# A1 Birtley to Coal House

## Scheme Number TR010031

### 7.5C Statement of Common Ground: Environment Agency

**STATEMENT OF COMMON GROUND: ENVIRONMENT  
AGENCY**

Figure 4: Improvements to channel and left bank flows for the Kingsway Viaduct river reach (TEAM\_5156.1) because of lowering the bank modular limits to 0.6 (option model)

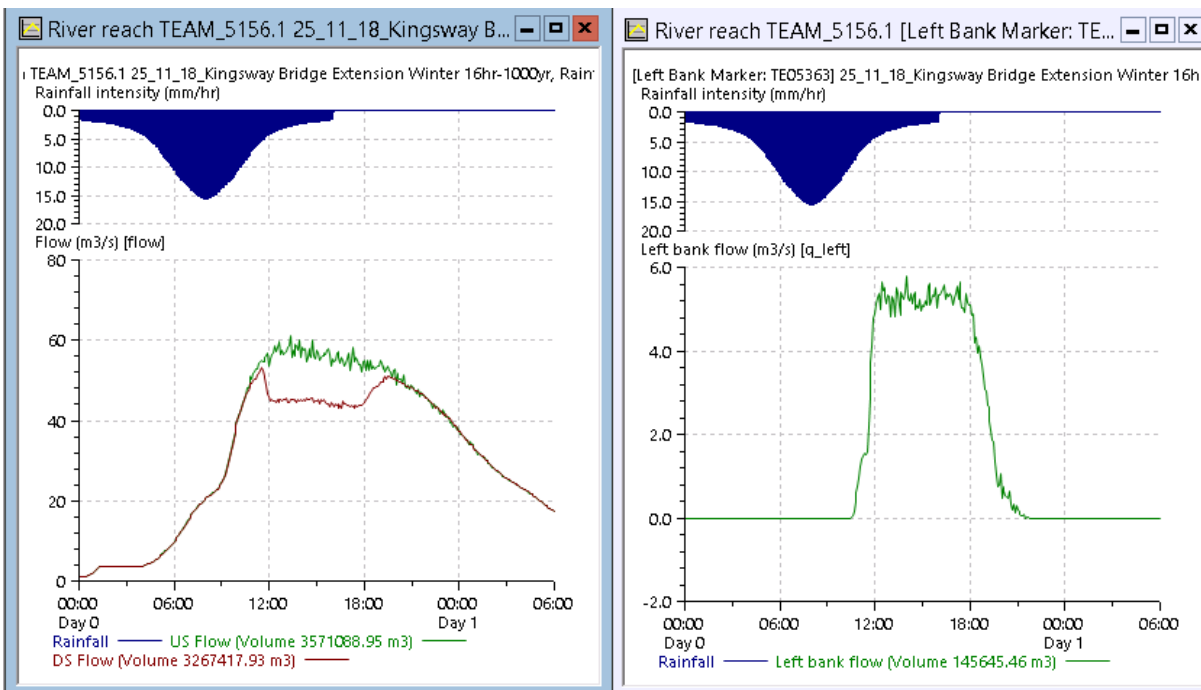
Lowering the bank line modular limit to 0.6 for the TEAM\_5156.1 river reach improved left bank flow for the option model, as shown in Figure 4, but caused the original basemodel provided by the EA to fail. The change in modular limit had no impact on in channel flows. The stability problem seems to be a wider issue with the model for example, river reach TE05820.1 directly upstream of the Kingsway Viaduct, shown in Figure 5, shows significant oscillations to in channel and left bank flows. Resolving stability issues with the wider approved and provided Environment Agency model (as developed by JBA) is not required as part of

An attempt was made to improve channel conveyance of river reach TEAM\_5156.1 however, this resulted in the model failing to run.

Figure 2: In channel flows at TEAM\_5156.1

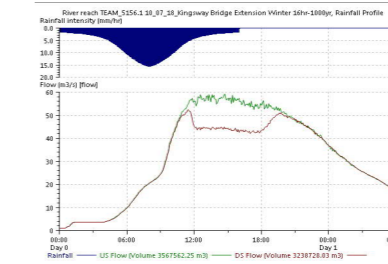
B-140	Total mass error = 9.9 m3	Acceptable		N/A
		B-141	Volume balance error = 0.9 %	Acceptable		N/A
		B-142	There is some oscillation in the peak flows in the area of interest during a 0.1% AEP event (Figure 2)	Minor issue	Make updates to conveyance and bank lines to improve stability	See response to B-29
		B-143	There is some significant oscillations in the out of bank flows in the area of interest during the 0.1% AEP event (figure 3)	Major issue	Make updates to conveyance and bank lines to improve stability. If appropriate, lower bank co-efficient	See response to B-29
	Sensitivity testing	- Suitability of sensitivity testing undertaken - Results & interpretation of sensitivity testing	B-144	Sensitivity tests not provided for review	Minor issue	Run sensitivity tests
Calibration / performance		B-145	No model performance testing was provided for review.	Minor issue	Use the model report to provide commentary on the sensibility of predicted flooding.	This is addressed within the accompanying technical note

Figure 3: Left bank flows at TEAM\_5156.1

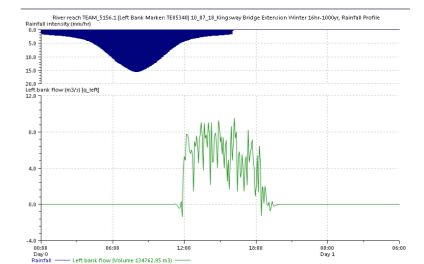
B-143	There is some significant oscillations in the out of bank flows in the area of interest during the 0.1% AEP event (figure 3)	Major issue	Make updates to conveyance and bank lines to improve stability. If appropriate, lower bank co-efficient	See response to B-29	The consultant has documented attempts to improve stability as suitably justified the approach and documented the limitations.	No further action required.	
Sensitivity testing	- Suitability of sensitivity testing undertaken - Results & interpretation of sensitivity testing	B-144	Sensitivity tests not provided for review	Minor issue	Run sensitivity tests	See response to B-137	The consultant has documented the model's sensitivity to channel roughness. This did not suggest any amendments to the base model where required.	No further action required.
Calibration / performance		B-145	No model performance testing was provided for review.	Minor issue	Use the model report to provide commentary on the sensibility of predicted flooding.	This is addressed within the accompanying technical note	The consultatn has provided justification for not completing model proving.	No further action required.
